MANDO PARKING LOT EXPANSION JSP24-11

Public Hearing at the request of Tower Construction LLC, for the Mando Parking Lot Expansion JSP24-11 for Preliminary Site Plan, Woodland Permit and Stormwater Management Plan approval. The subject parcel is zoned I-1, Light Industrial and is located east of Hudson Drive and south of Hexagon Way in the Beck North Corporate Park. The applicant proposes to construct a new 37-space employee parking lot and is seeking approval to remove 53 regulated woodland trees.

PLANNING REVIEW

Review Date: April 4, 2024
Review Type: Revised Final Site Plan
Project Name: JSP24-11: Mando Parking Lot Expansion
Location: Beck North Corporate Park
Plan Date: March 19, 2024
Prepared by: Heather Zeigler, Planner
E-mail: heigler@cityofnovi.org; **Phone:** (248) 347-0579

Figure 1. City of Novi Regulated Woodlands Map
Approximate parcel boundary is shown in Red.
(Approximate) Regulated Woodland areas are shown in Green

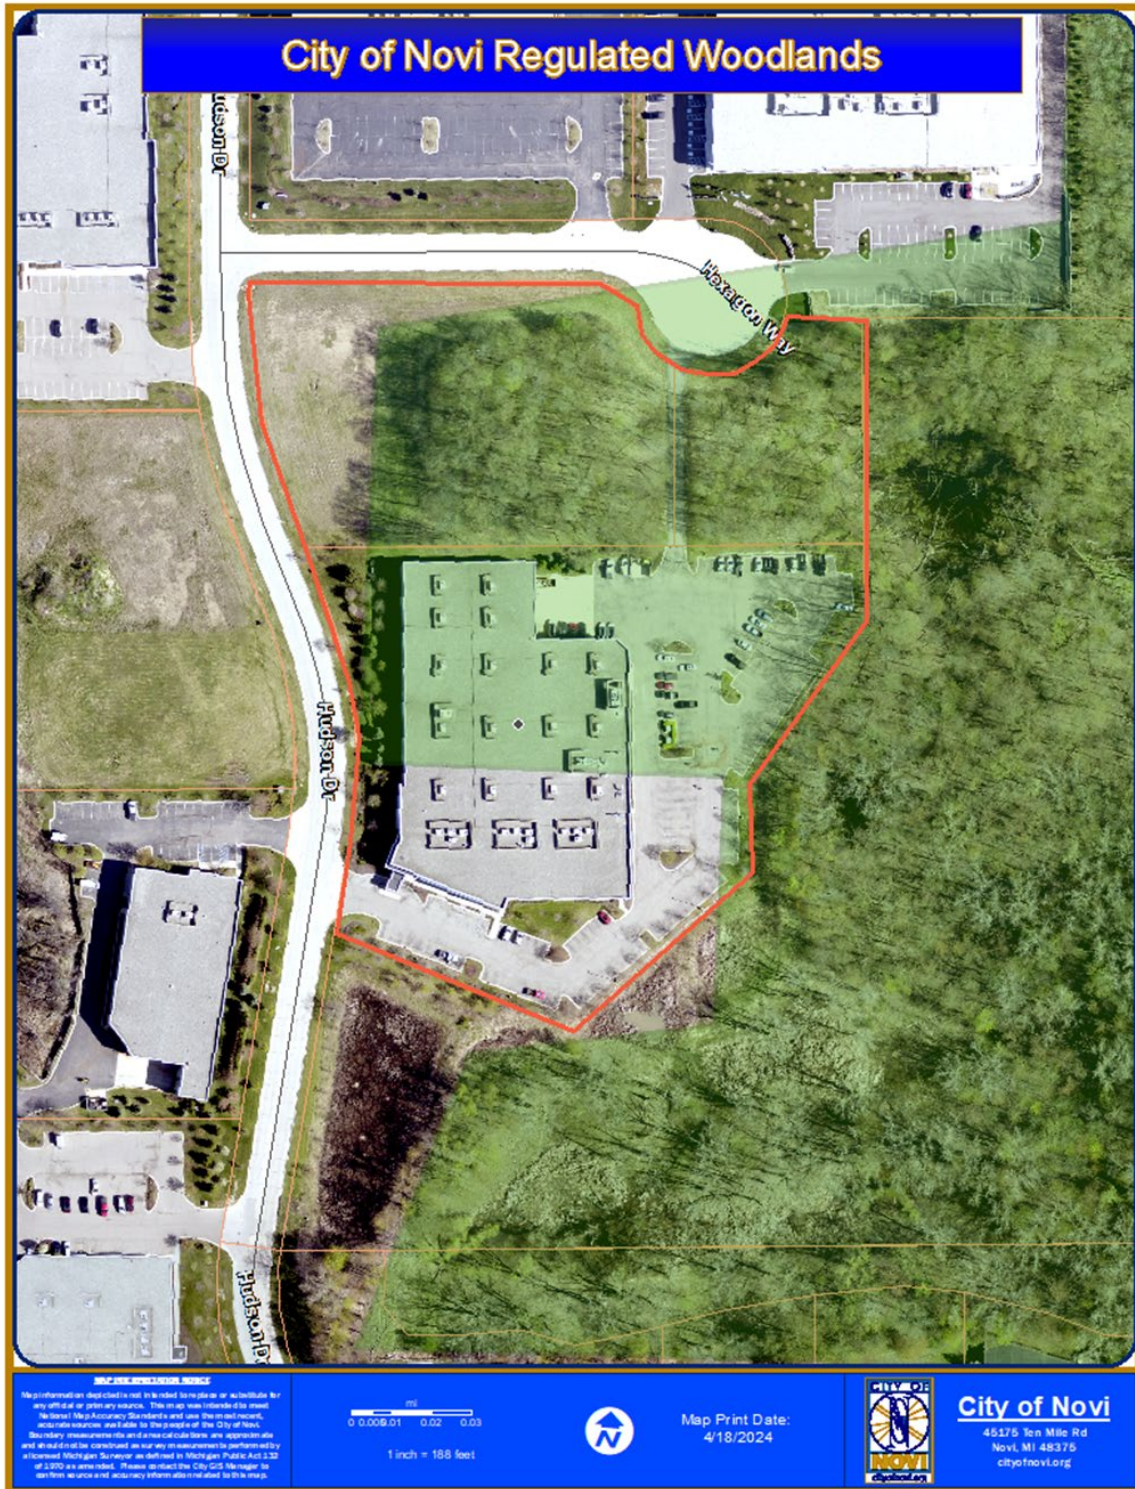
1. City-regulated woodlands, as identified on the City of Novi Woodlands interactive map website, are present onsite. Note that both the woodlands and property limits depicted on the City map are considered approximations (**Figure 1**).
2. Merjent conducted a site visit on July 12, 2024 to review the site conditions relative to the PSP submittal. Site photographs are included in **Attachment A**. The on-site conditions reflect the conditions listed in the PSP.

Figure 2. City of Novi Regulated Wetlands Map
 Approximate parcel boundary is shown in red.
 (Approximate) Regulated Wetland areas are shown in turquoise.

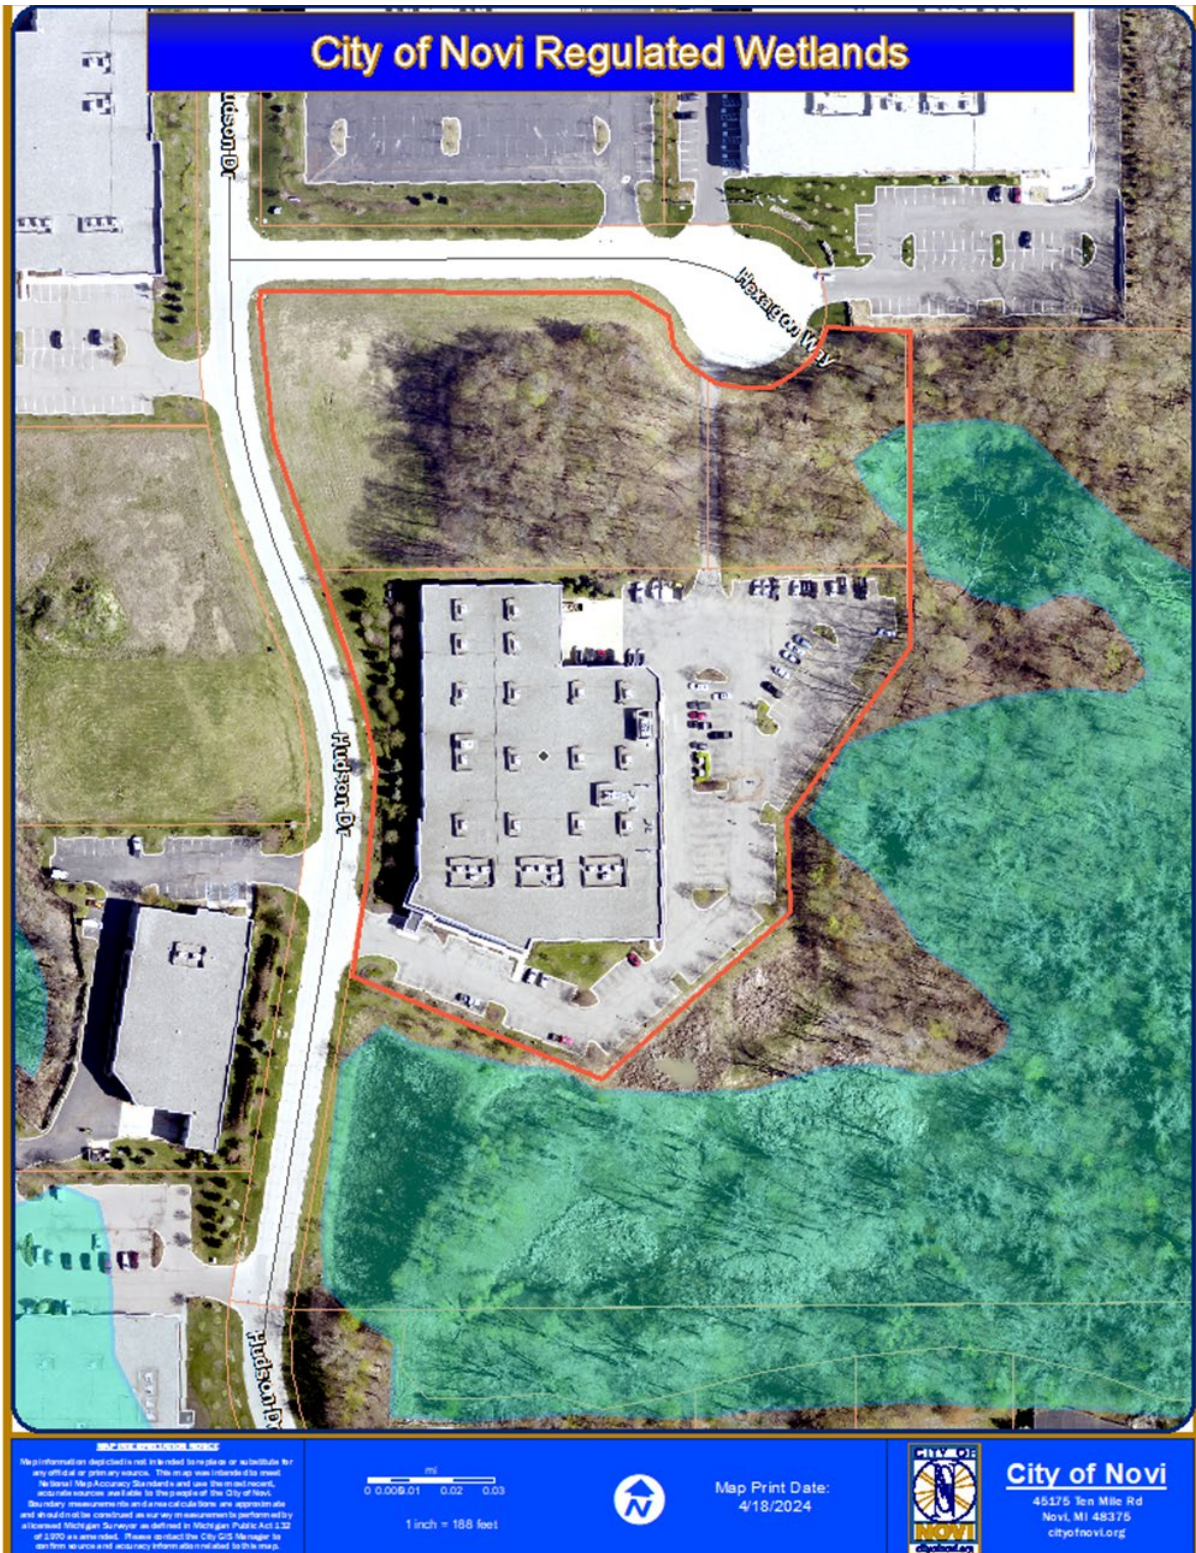
- City-regulated wetlands, as identified on the City of Novi interactive map website. Note that both wetland and property limits depicted on the City's map are considered approximations (**Figure 2**).
- Wetlands that are regulated by the Michigan Department of Environment, Great Lakes, and Energy (EGLE).
- Wetlands as identified on National Wetland Inventory (NWI) and Michigan Resource Inventory System (MIRIS) maps, as identified on the EGLE Wetlands Viewer interactive map website (**Attachment B**). NWI and MIRIS wetlands are identified by the associated governmental bodies' interpretation of topographic data and aerial photographs.
- Hydric (wetland) soil as mapped by the U.S. Department of Agriculture, Natural Resources Conservation Service, as identified on the EGLE Wetlands Viewer interactive map website (**Attachment B**).
